Groundwater Application Review Summary Form

Application # G- 19465

GW Reviewer James Hootsmans Date Review Completed: 2/21/2025

TO: Water Rights Section Date 2/21/2025
 FROM: Groundwater Section James Hootsmans
 Reviewer's Name
 SUBJECT: Application G- 19465 Supersedes review of _____
 Date of Review(s)

Well Statistics

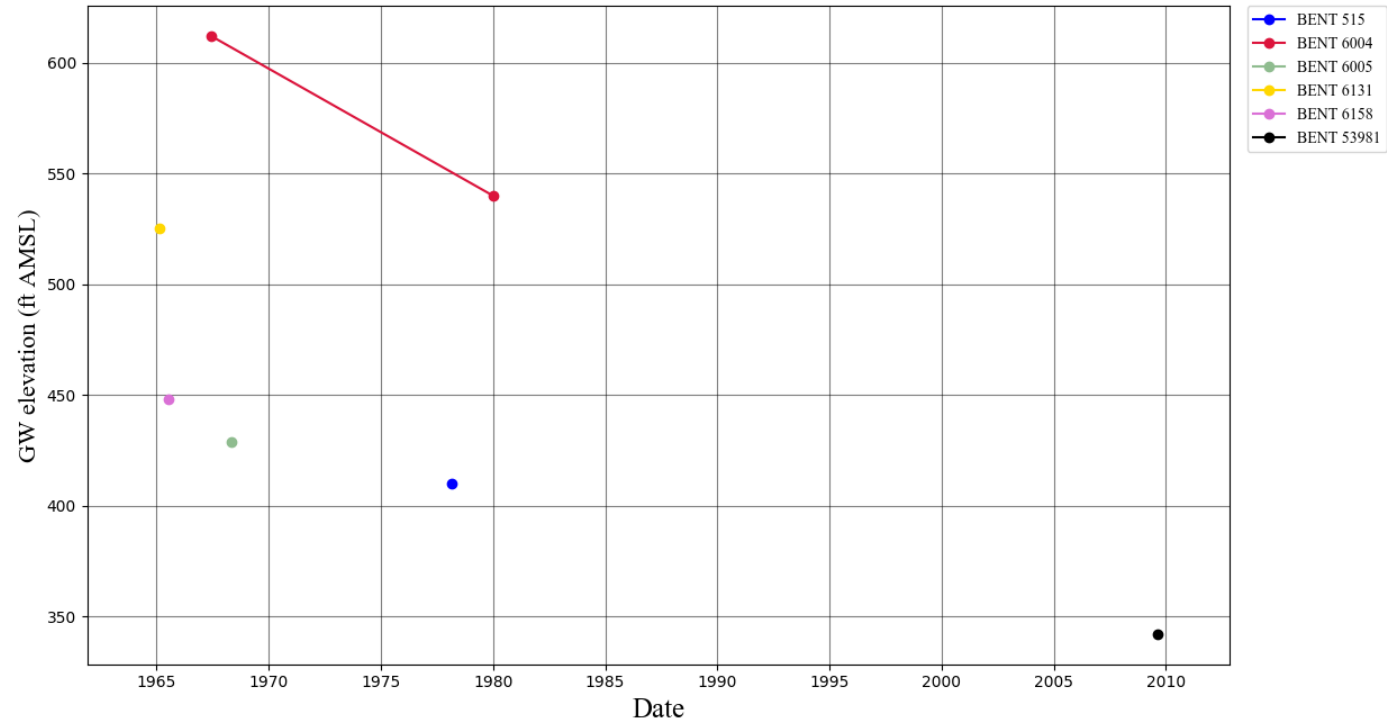
Reported yields from regional wells (TRS 12S 6W 26 and surrounding sections) range from less than 1 to ~90 gpm, with a median of 20 gpm (see attached Well Statistics). The proposed rate of ~27.4 gpm (~0.061 cfs) is slightly more than the median yield reported for water wells in this area, and about a quarter of the maximum reported yield.
